**Carlyle/Eisenhower East Design Review Board (DRB)
Application**

PROJECT NAME: Blocks 4+5 Hoffman Town Center BLOCK: 4+5

Carlyle Design Review Board
Submission-July 18, 2019 Hearing
2410 & 2460 Mill Road
HTC Block 4 & 5
19-0007

RE: Hoffman Town Center, Blocks 4 & 5
DSUP #2019-0018
Comment Response Letter
Cooper Carry project# : 20160037

APPROVED DSUP
12/19/2017

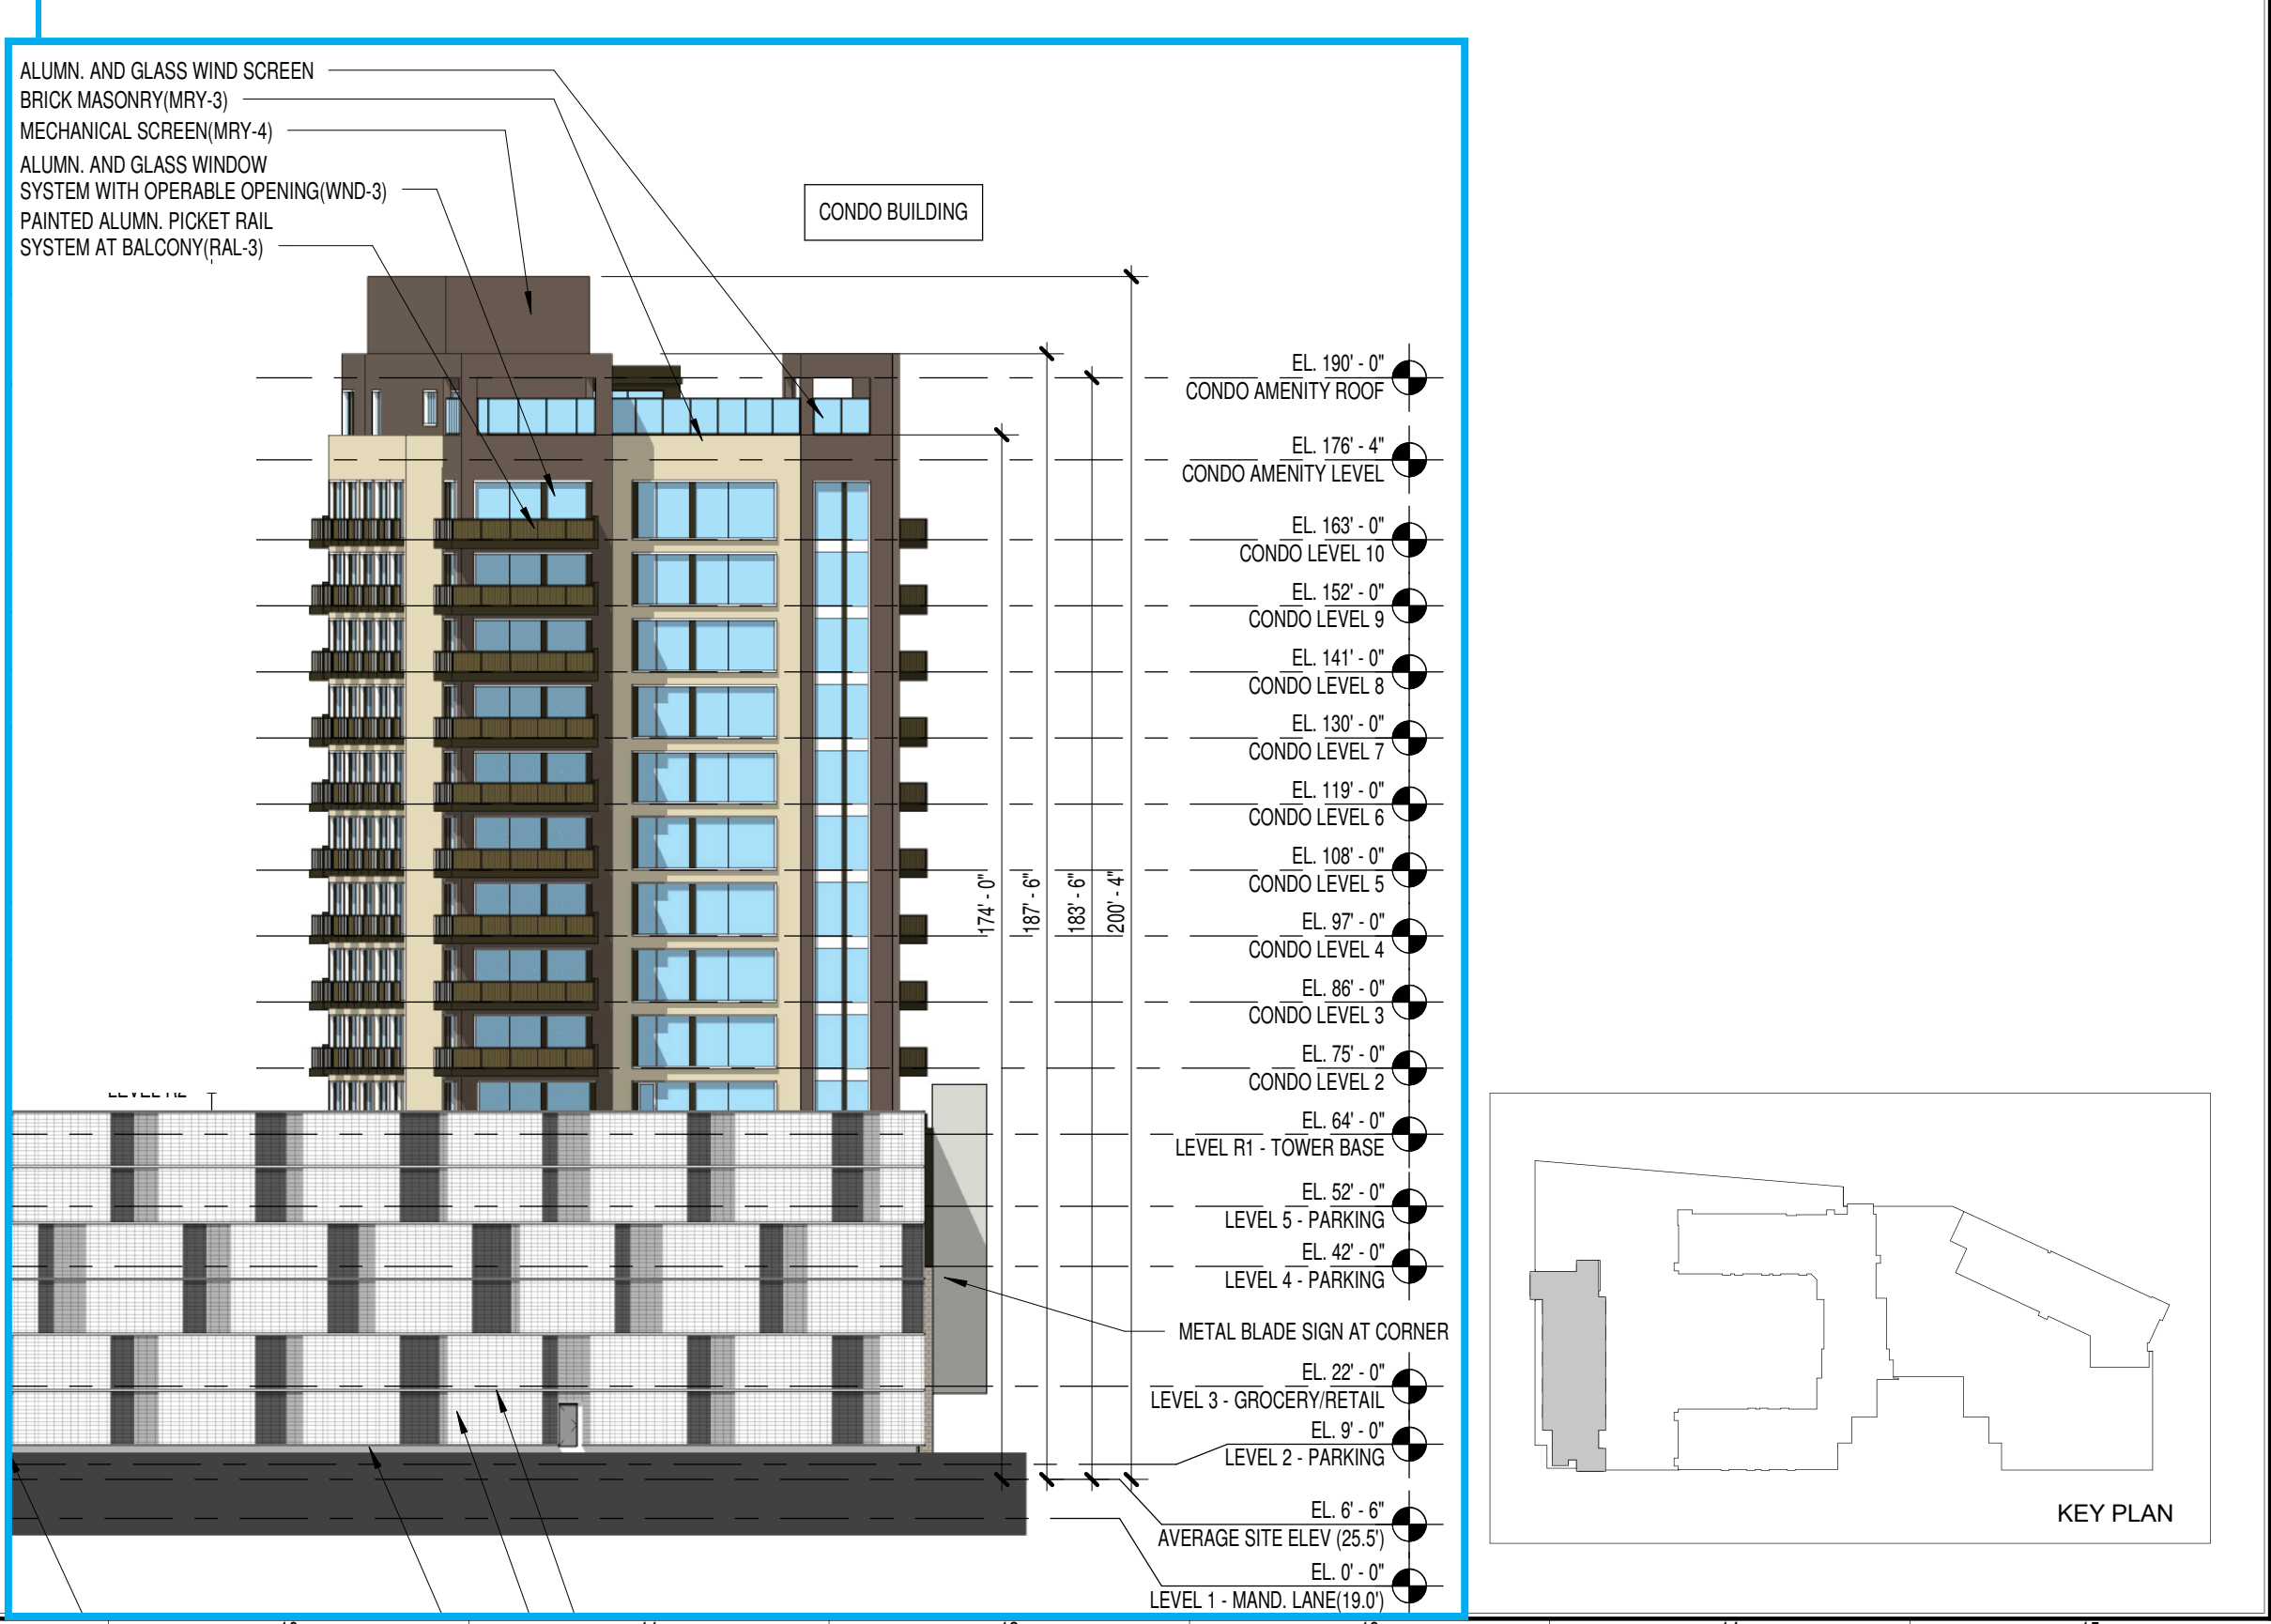
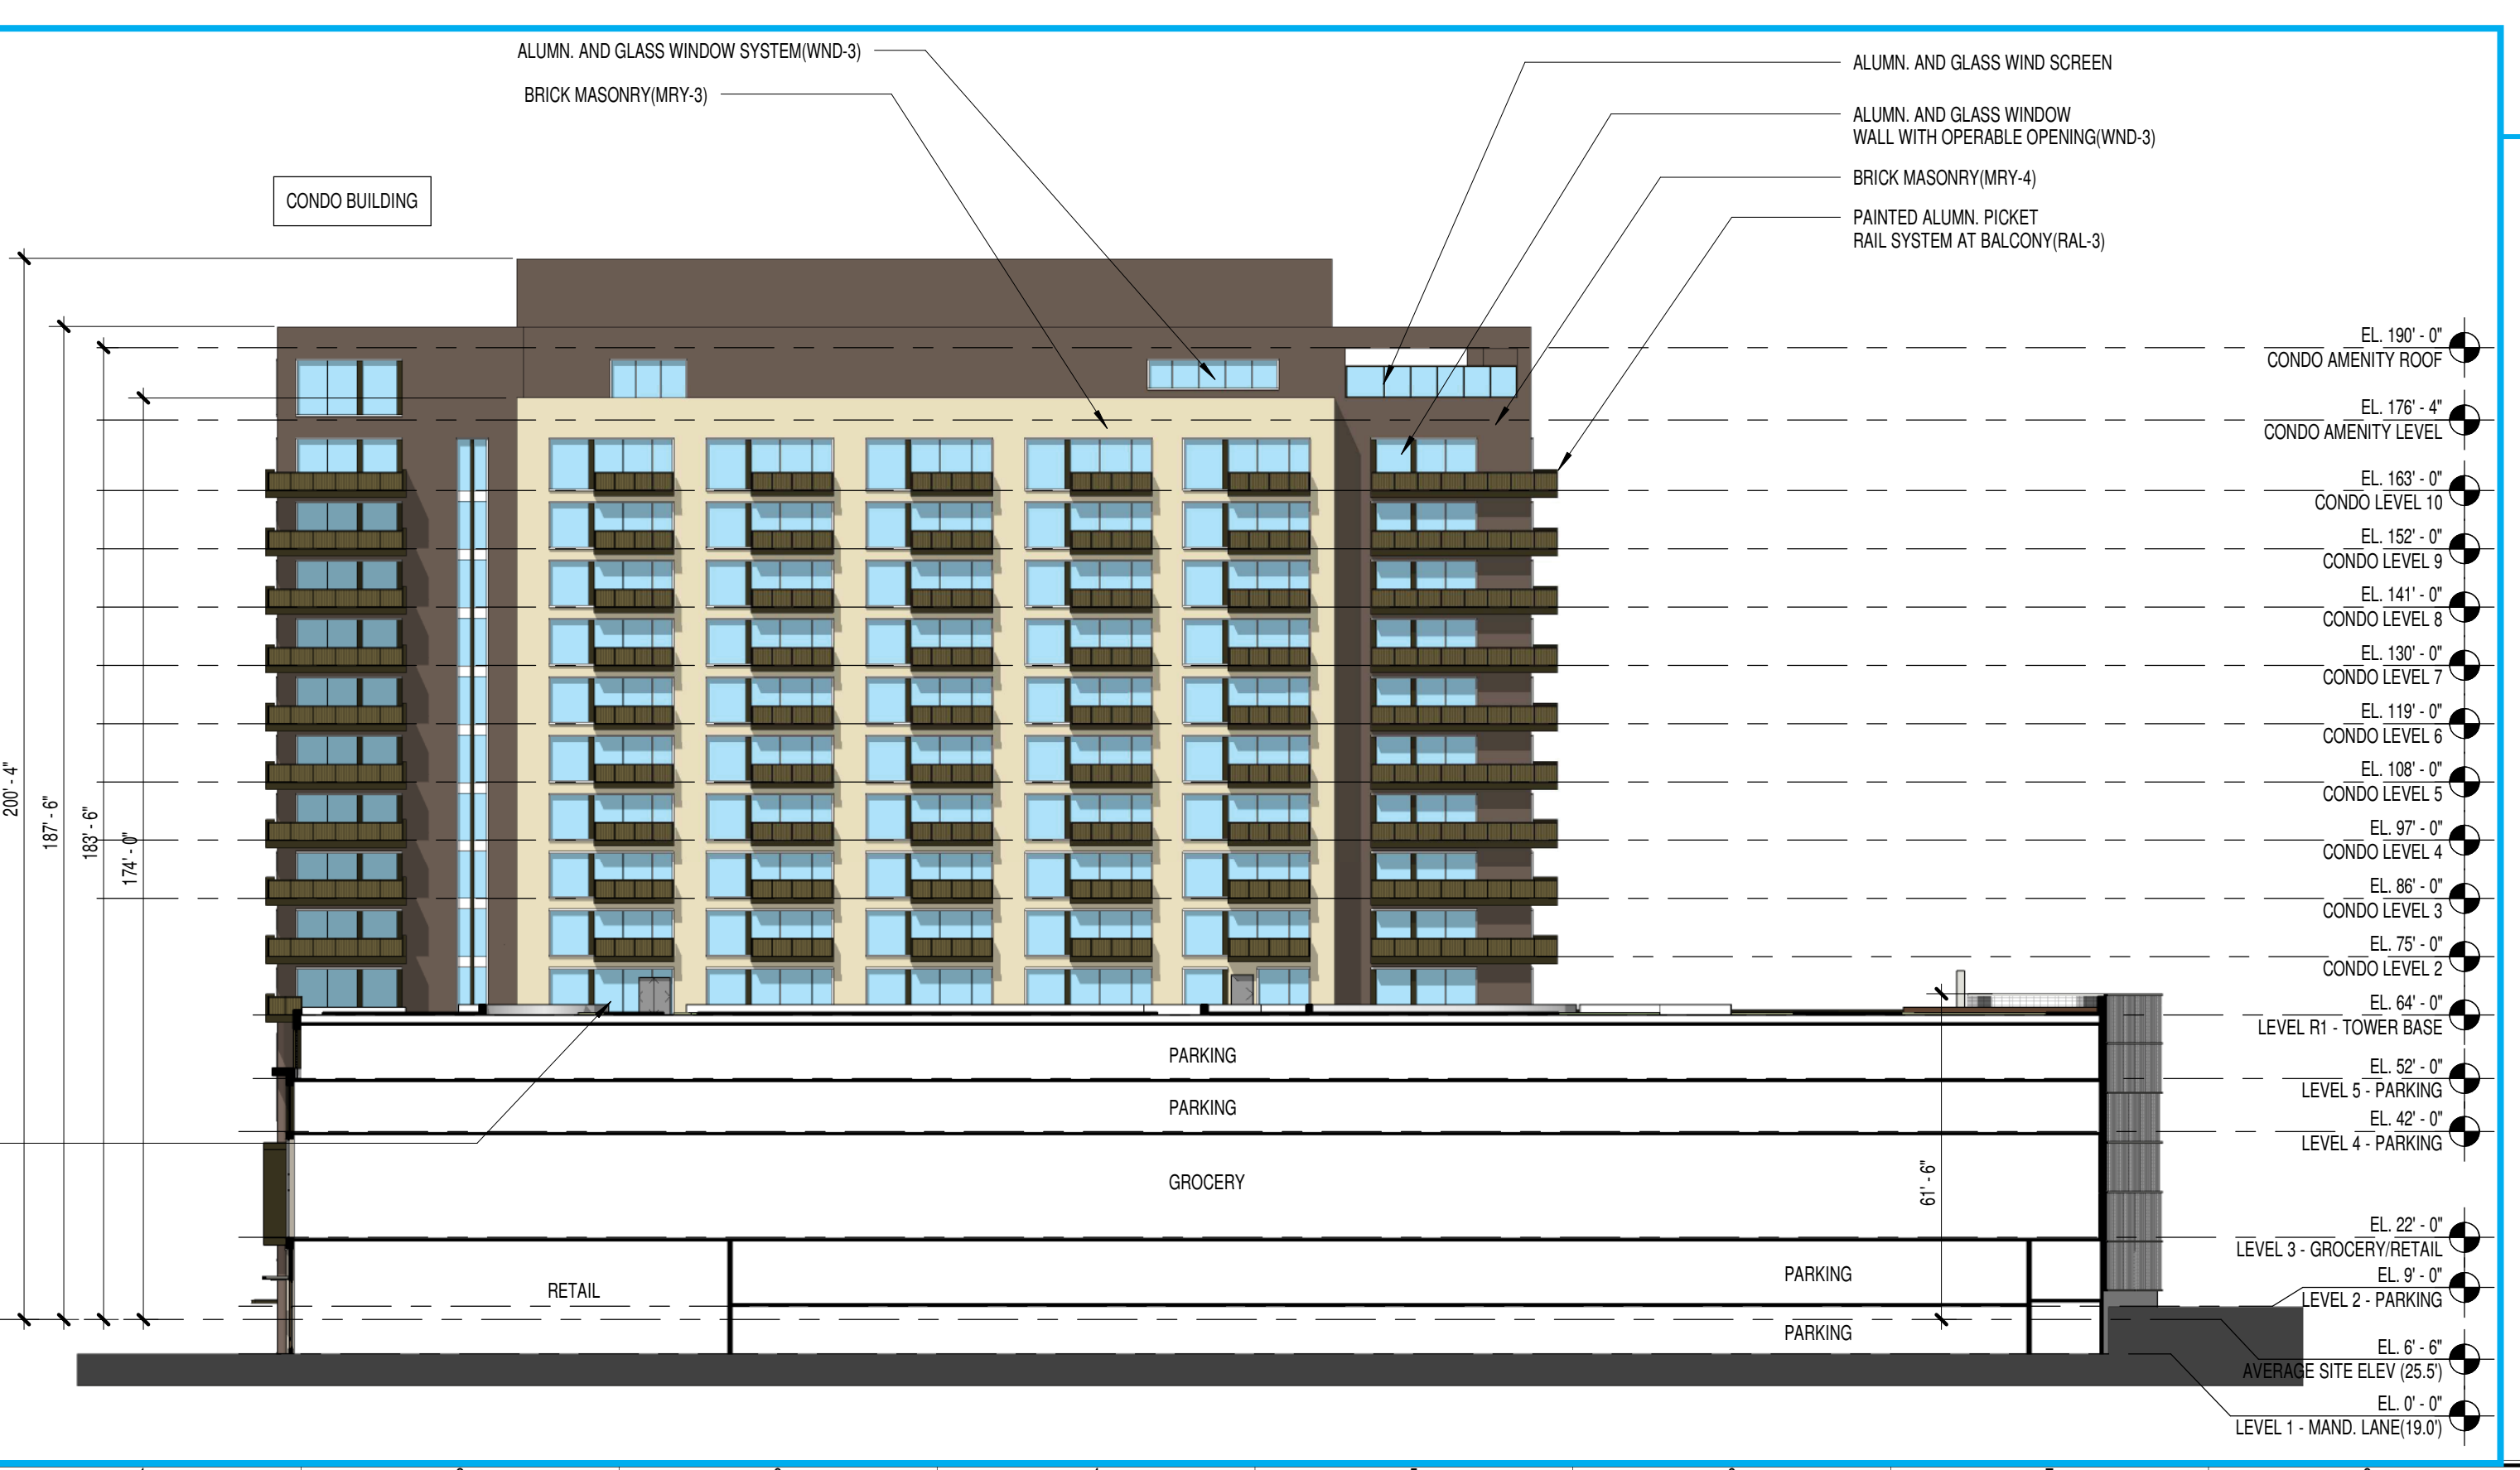
- h. The bays spacing on the approved east elevation reflected the west elevation, now incorporates varied bay and pier widths, creating a symmetrical pattern that diminishes the strongly asymmetric cues of the approved design.

- g. The west half of the north elevation has been completely changed from primarily glass to primarily solid, again with a change from large to small windows, a complete change in wall and opening proportions, and the relocation of many balconies.

Response: Glazing has been restored with the exception of one window on the east elevation which was removed due to a change in the program of the space now reserved for mechanical equipment.

Response: The difference in bay spacing has been driven by the change in program from a condominium to an apartment building. Although the number of units has increased, the five-bay rhythm has remained on each elevation and has been revised to match the approved DSUP as much as possible. Due to constraints regarding the building’s structure, as well as unit configuration, the glazing on the east elevation resulted in a symmetrical pattern.

Response: The north elevation's modification is reflected in the change in footprint in the DSUP Amendment. With this footprint change, the interior units have been changed as well. The glazing has been maximized as much as allowed by the interior unit layout with floor-to-ceiling glass where appropriate. The balcony on the west half continues to wrap the corner and the elevation is further enhanced with the addition of a larger balcony to the adjacent cream-color portion.
